Record of Decision

Nyack Gas Plant Site

Operable Unit No.1

Site Number 3-44-046

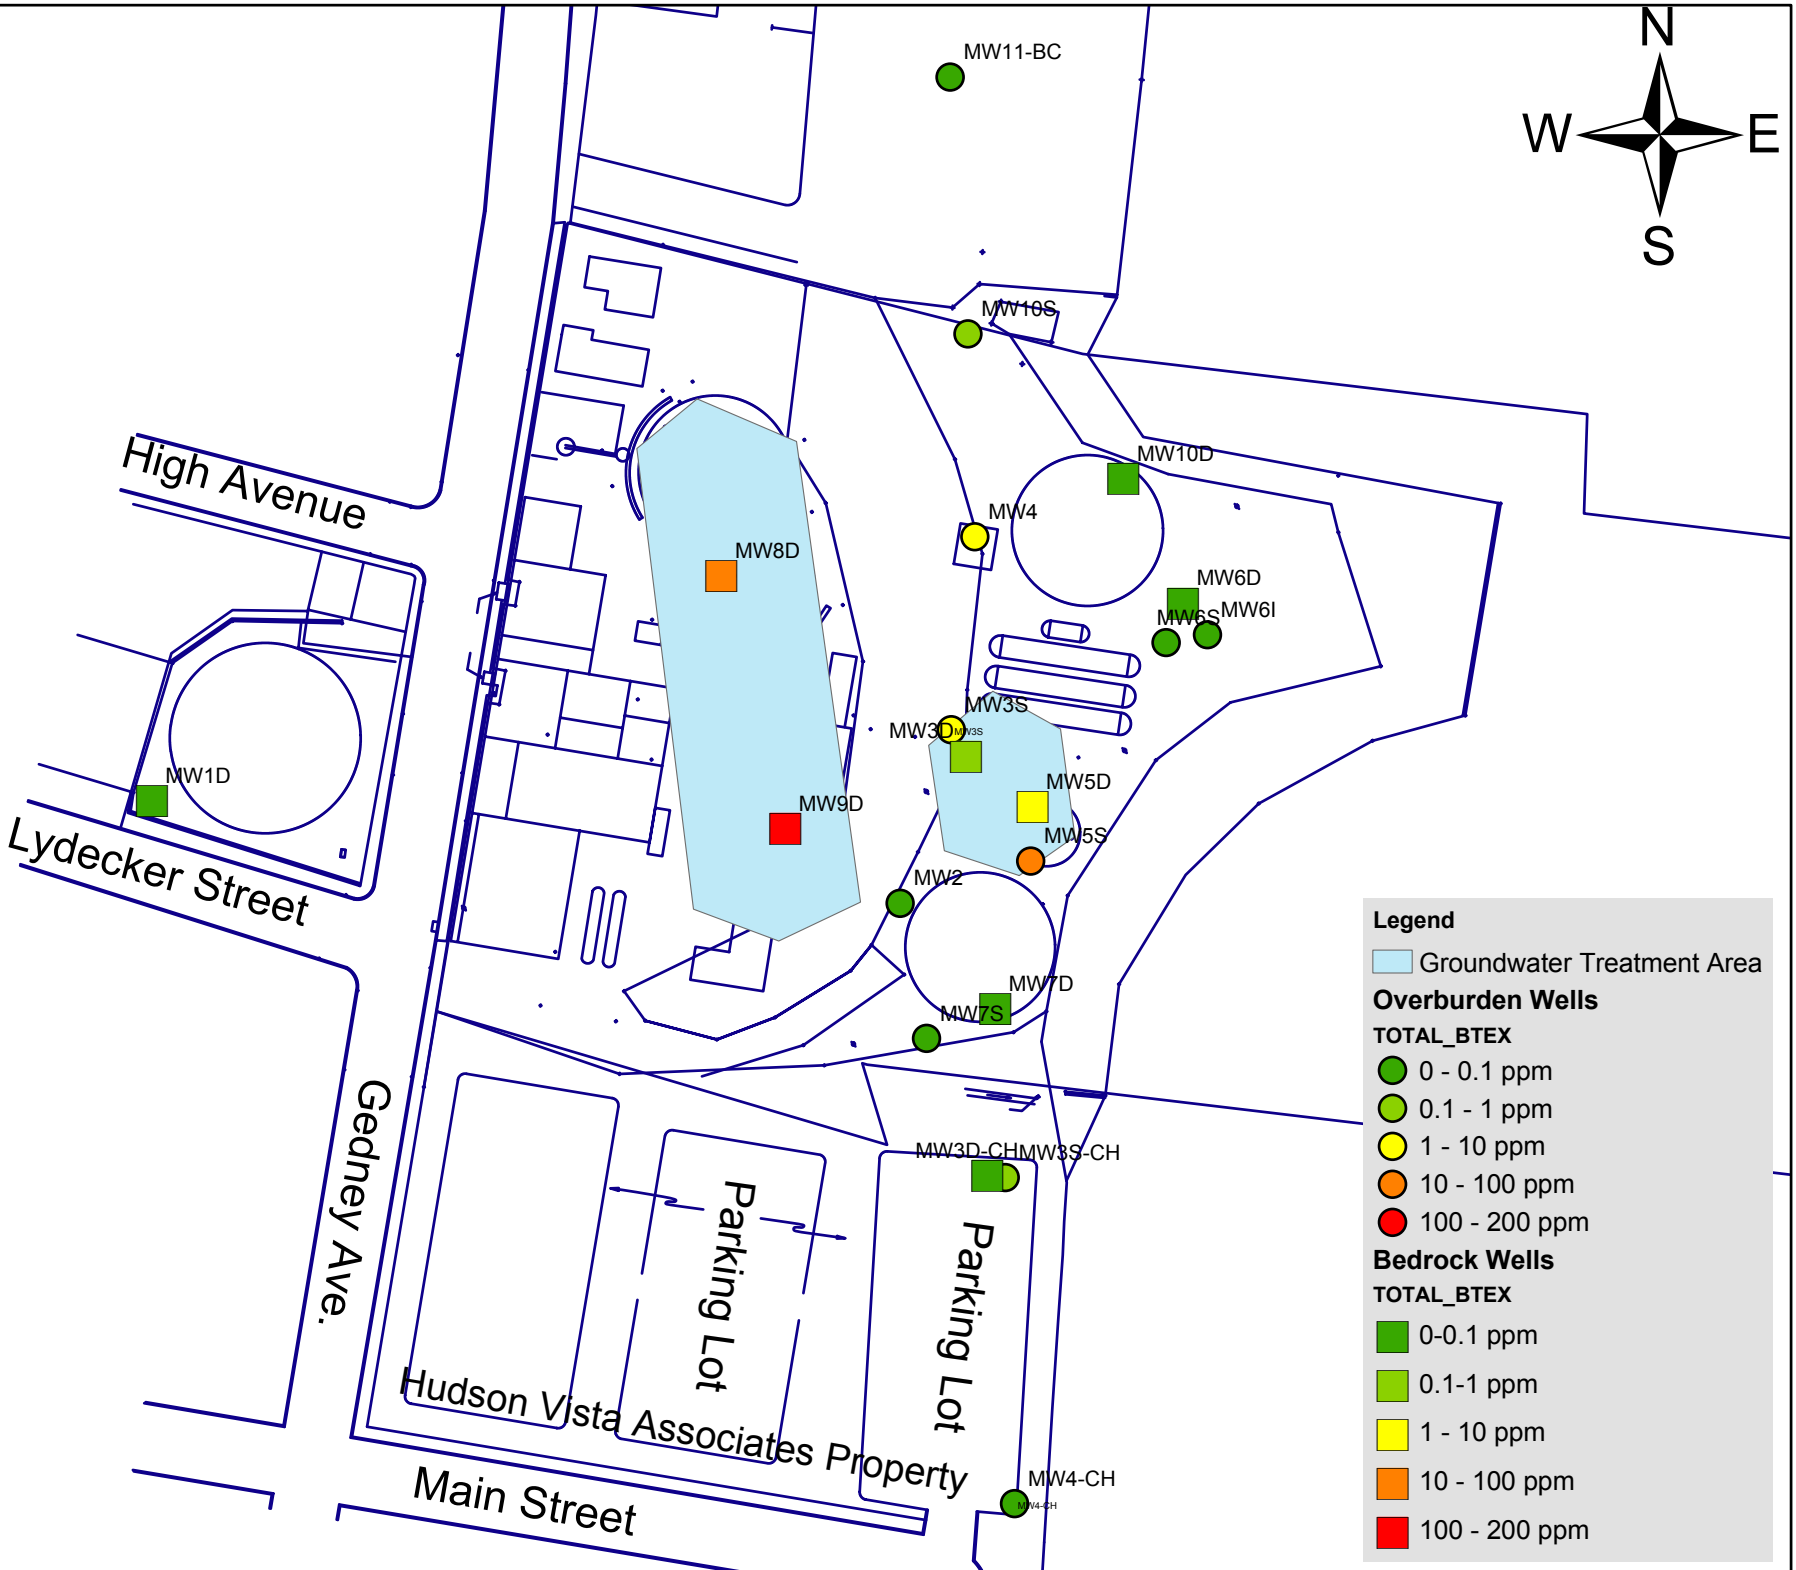
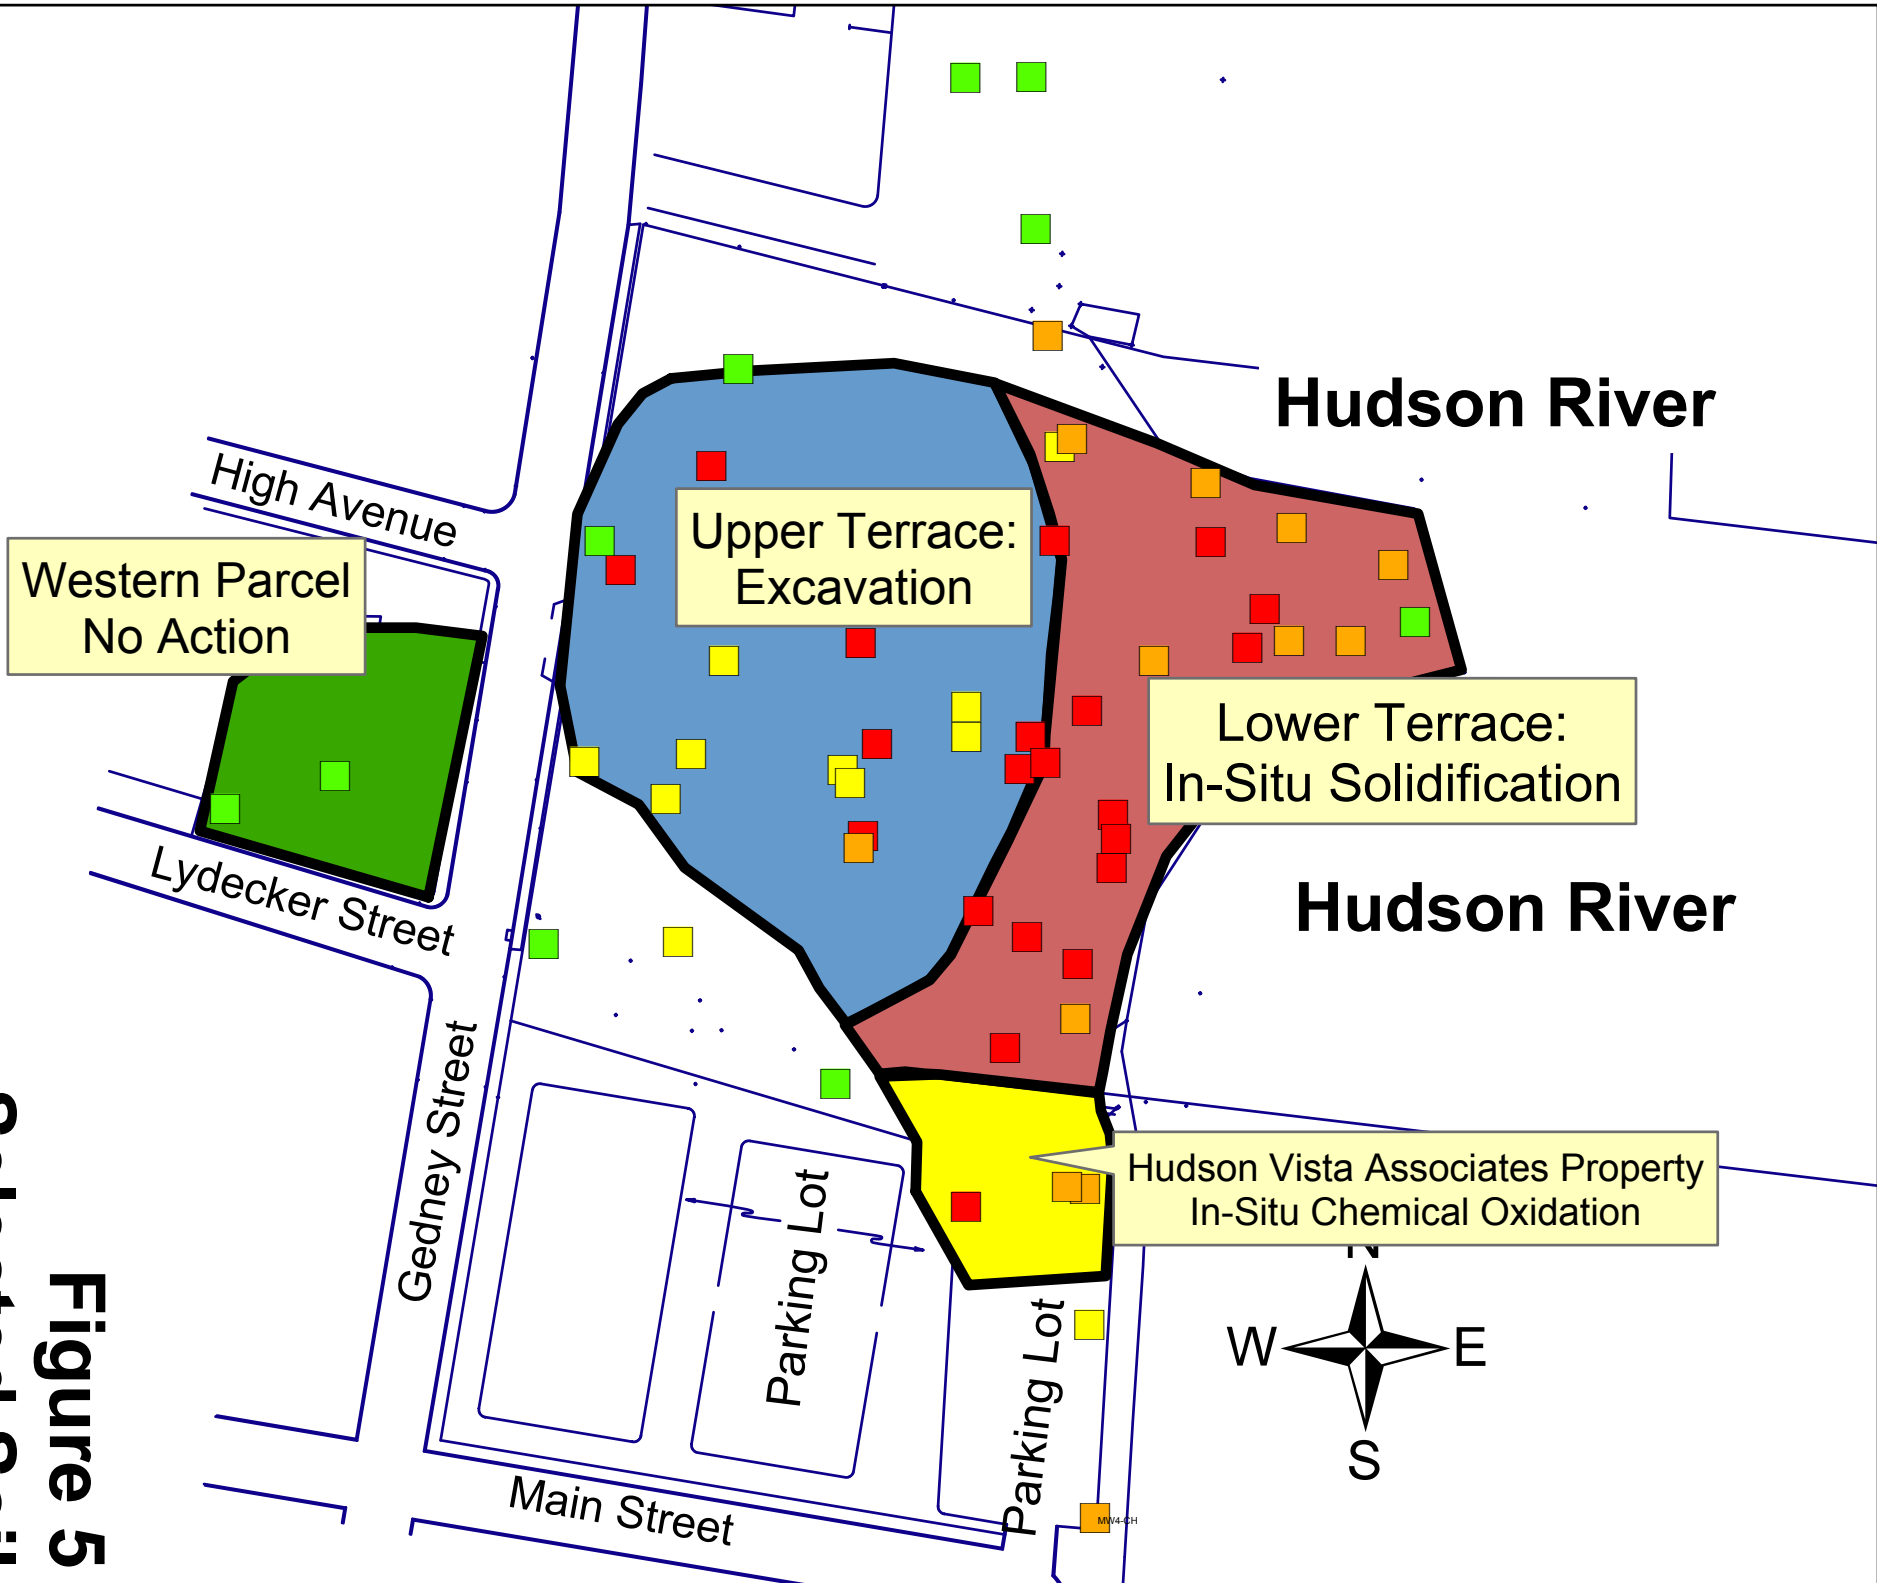
COMMENT 44: It is difficult to determine by the figures in the PRAP if the extent of soil and groundwater contamination have been defined to TAGM levels and groundwater standards, respectively. The contaminant levels on Figures 3 and 4 are represented as ranges, therefore, it is difficult to determine the actual concentrations of each contaminant at each sampling location. Of particular concern is that no sampling appears to have been conducted on the west side of Gedney Avenue at its intersection with High Avenue. I respectfully request that the actual concentrations at each sampling location be provided to the public. If these data indicate that additional sampling, including new monitoring wells and soil borings, are required to fully define the extent of contamination, I respectfully request that the soil and groundwater contamination be fully defined and remediated and that any proposed work to do so be made available to the community.

RESPONSE 44: The actual results of each sampling point are provided in the Remedial Investigation Report, which is in the document repository. This report defines the nature and extent of contamination at this site. Based on a full review of this data, additional investigation work was called for in the ROD. The additional investigation includes work on the west side of Gedney Avenue; soil borings south of High Street, and soil gas points both north and south of High Street. No additional groundwater investigation is necessary based on existing data. When the work plan for this work is finalized, it will be added to the document repository, as will results of this investigation. The definition of the extent of contamination and remediation will be further clarified during the design process.
